Subject: Revision to MHI's RAI Responses on US-APWR DCD Chapter 15.6.5 SBLOCA

**Revision to MHI's RAI Responses on US-APWR DCD Chapter 15.6.5
SBLOCA**

RAI NO.: NO. 352-2369 REVISION 1
SRP SECTION: 15.06.05 – LOSS OF COOLANT ACCIDENTS RESULTING FROM SPECTRUM OF POSTULATED PIPING BREAKS WITHIN THE REACTOR COOLANT PRESSURE BOUNDARY
APPLICATION SECTION: 15.6.5
DATE OF RAI ISSUE: 5/4/2009

Figure RAI-15.6.5-33.1 PCT Sensitivity of Maximum Time Step Size for DVI Line Break

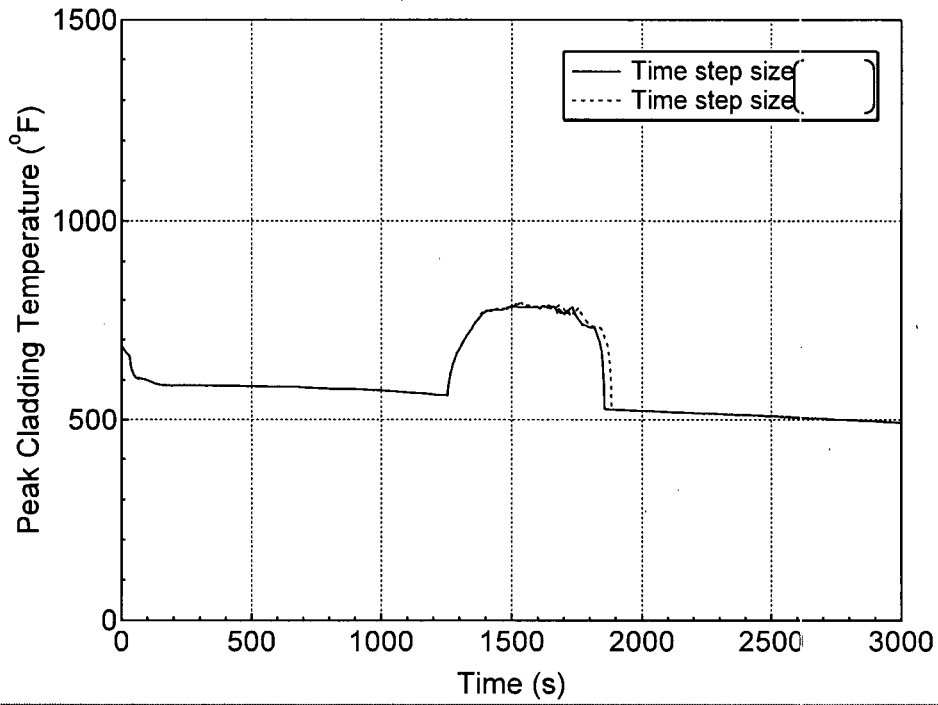
Section 4.2.4 (MUAP-07025-P) indicates that the maximum time step sizes used for 7.5- inch and 1-ft² break analysis are larger than the time step size for the DVI break analysis. This appears to be contradictory to expectations, since larger break transients may require smaller time steps due to more rapid changes. Discuss how these maximum time steps were chosen. What are the maximum time step sizes for other break sizes and locations?

In generally, a transient with larger break size requires smaller time step size due to the Courant limitation for the semi-implicit numerical scheme which is applied to M-RELAP5. In all calculations by M-RELAP5, including the both plant and experimental test calculations, the automatic time step algorithm is used, in which the applied time step size is determined not to violate the hydraulic Courant number in all the calculation nodes. In addition, adequacy of the maximum allowable time step size is verified in the process of the plant calculation as is described in the technical report MUAP-07025-P (R2) (Ref.1). In the report, the maximum allowable time step size used for the DVI break is smaller than that for the 7.5-in break, and is same as that for the 1-ft² break (Table RAI-15.6.5-33.1). This seems to be contradictory to the numerical theory described above, since the maximum coolant velocity is expected to be smaller in the DVI break than in the 1-ft² break.

MHI has performed an additional time step sensitivity calculation for the DVI injection line break so as to re-evaluate the applicable time step size. Specifically, the maximum allowable time step of [], which is same as the time step size for the 7.5-in cold leg break, is applied and its sensitivity on the cladding temperature is confirmed. The result of the cladding temperature is shown in Figure RAI-15.6.5-33.1, and is compared with the result obtained using the reference time step size ([]) in Reference 1. The figure shows [] is small enough for the DVI line break calculation, as well as for the 7.5-in break calculation. It is noted that a coarser time step size ([]) is sufficiently applicable for cold leg breaks of less than 6-in since no heat-up occur during the transients. In conclusion, the relation of applicable time step sizes for all the break cases, including the DVI break, is consistent with the expectation from the numerical theory.

However, the time step size required to simulate the transient accurately differs from the case where the different break location is assumed even if the break sizes are mutually identical in the two cases. This is because the phenomenon of interest and the location providing the Courant limitation might be different in the two calculations. MHI has individually determined the maximum time step sizes used for 7.5-inch (and 1-ft²) and DVI break cases, based on the sensitivity analysis in terms of the time step. **Table RAI-15.6.5-33.1** shows the relation between the break position, location and the maximum allowable time step determined for the US-APWR SBLOCA sensitivity calculations described in MUAP-07025-P (R0).
